**OFFICER'S REPORT FOR:**

**Proposed Porirua District Plan: TR-Transport**

**Rory Smeaton, Senior Policy Planner**

**3 December 2021**

**B85 Vehicle (Realistic min radius) (2004)**

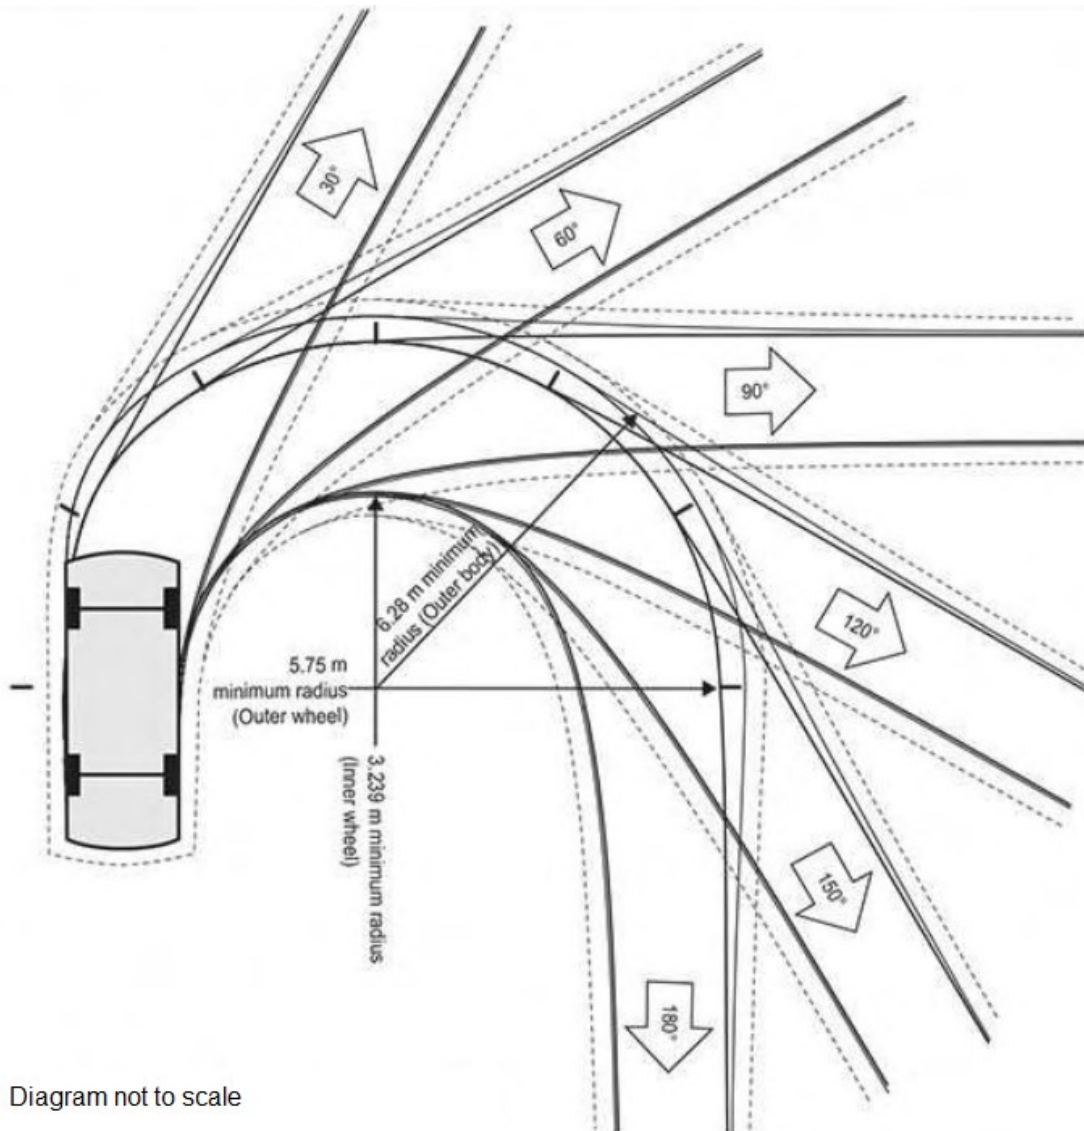
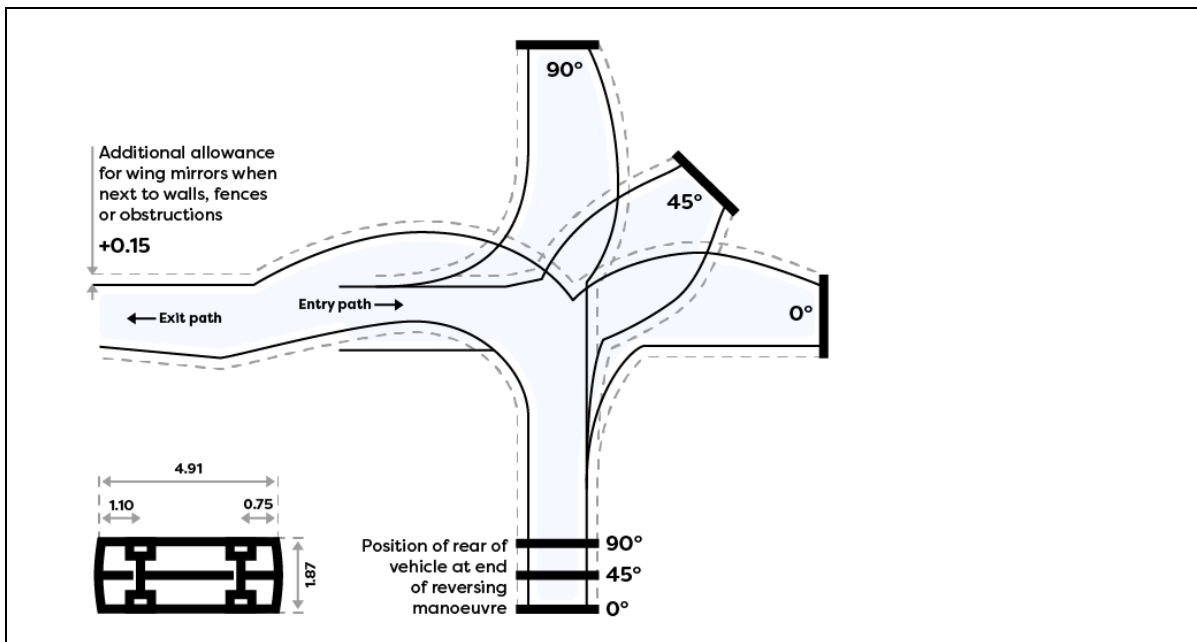
217. Porirua City Council [11.32 and 11.33] seeks that the clearance width in TR-S6-1 and the associated figure TR-Figure 4 be increased from 150 millimetres, to 300 millimetres. The reasons given are that the 300 millimetre clearance is consistent with other New Zealand standards. Further submissions from Kenepuru Limited Partnership [FS20.40], Paremata Business Park [FS64.18] and Carrus Corporation Limited [FS62.24] opposed the submission [11.32].

219. Kāinga Ora [81.397] seeks that TR-Figure 4 is deleted, with review and amendment to appropriately manage the safety and efficiency of the transport network, while recognising and providing for residential intensification.

225. Kāinga Ora [81.397] also seeks review of TR-Figure 4. This figure is based on Figure B8 in AS/NZS 2890.1:2004. I agree that this may not be the correct figure to use in all situations, as this figure relates specifically to reverse-in manoeuvres. The standard states that this is intended 'for use only at residential or domestic car parks to cater for unusually shaped manoeuvre areas in front of parking spaces'.<sup>11</sup> The figure should instead be Figure B5 in AS/NZS 2890.1:2004 which shows tracking curves for an 85<sup>th</sup> percentile car with a 5.8 metre radius turn. I have recommended an appropriate figure to replace the current figure, which also includes the dimensions of the B85 motor vehicle, as recommended by Ms Fraser in her evidence.

- a. Amend TR-S6 and TR-Figure 4 as set out below and in Appendix A;

11.32 <sup>125</sup>	Porirua City Council	TR-S6	Amend the standards as follows:  2. On-site vehicle manoeuvring areas must provide for a 4.91m x 1.87m vehicle (85th percentile vehicle) as shown in TR-Figure 4 Manoeuvring, including additional width of <del>150</del> <u>300</u> mm per affected side to allow for wing mirrors when manoeuvring areas are bordered by walls, fences or obstructions.	3.10.5	Accept	See body of the report	Yes

81.397	Kāinga Ora – Homes and Communities	TR-Figure 4	Delete Figure	3.10.5	Accept in part	See body of the report	Yes
11.33	Porirua City Council	TR-Figure 4	Amend the figure as follows:  <del>+0.150.3</del>	n/a	Accept	The change is consistent with that recommended in section 3.10.5.	Yes

**TR-Figure 10**      **Approach Sight Triangles for Level Crossings with “Stop” or “Give Way” Signs**<sup>96</sup>

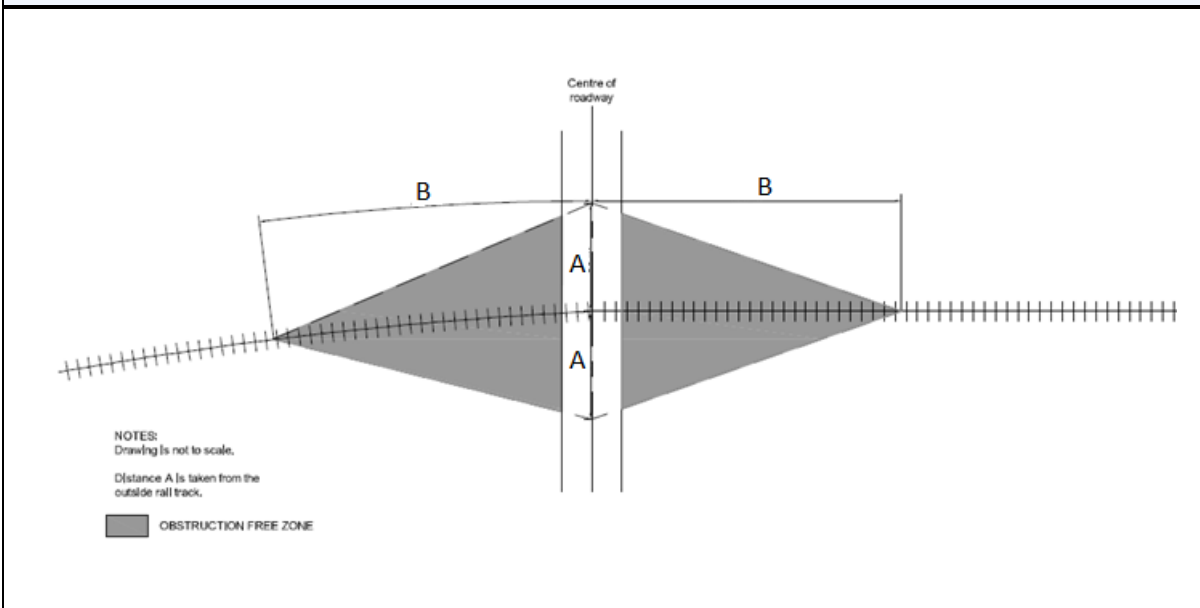
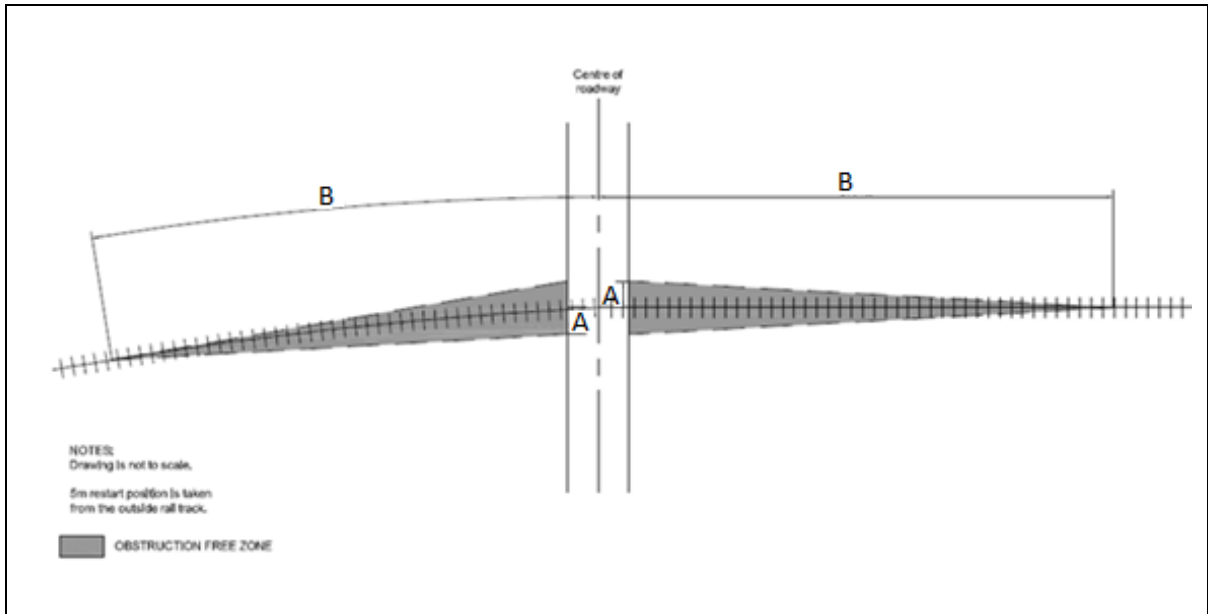
37. The submitter is correct that the Plan lacks provisions to protect sight lines at railway level crossings. This is likely to be due to a drafting error, as provisions were included in the Draft District Plan that was released for consultation in 2018. I note that in her evidence, Ms Fraser has agreed that the Plan should include standards in relation to railway level crossings.

39. Provisions to protect sight lines at railway level crossings would give effect to strategic objective FC-O1, as well as objective INF-O4 and policy INF-P5. As such, I agree with KiwiRail that the Plan should be amended to include provisions to protect sight lines at railway level crossings.

47. I recommend for the reasons given in the assessment, that the Hearings Panel:
  - a. **Add** a new rule and standard addressing sight lines at level rail crossings as set out in Appendix A;

<b>TR-S12</b>	<b><u>Railway level crossing sight lines</u></b> <sup>94</sup>	
<b><u>All zones</u></b>	<p><u>1. Buildings, structures and planting must not be located within the sight distance areas defined in TR-Table 10 and shown in TR-Figure 10 and TR-Figure 11.</u></p>	<p><u>Matters of discretion are restricted to:</u></p> <ol style="list-style-type: none"> <li><u>1. The safe and efficient functioning of the transport network;</u></li> <li><u>2. The safety of people using the road and railway crossing; and</u></li> <li><u>3. Site limitations, configuration of buildings and activities, demonstrated user requirements and operational requirements.</u></li> </ol>
<b>TR-Table 10</b>	<b><u>Approach and Restart Sight Distances at Railway Level Crossings</u></b> <sup>95</sup>	
	<b><u>Distance (m)</u></b>
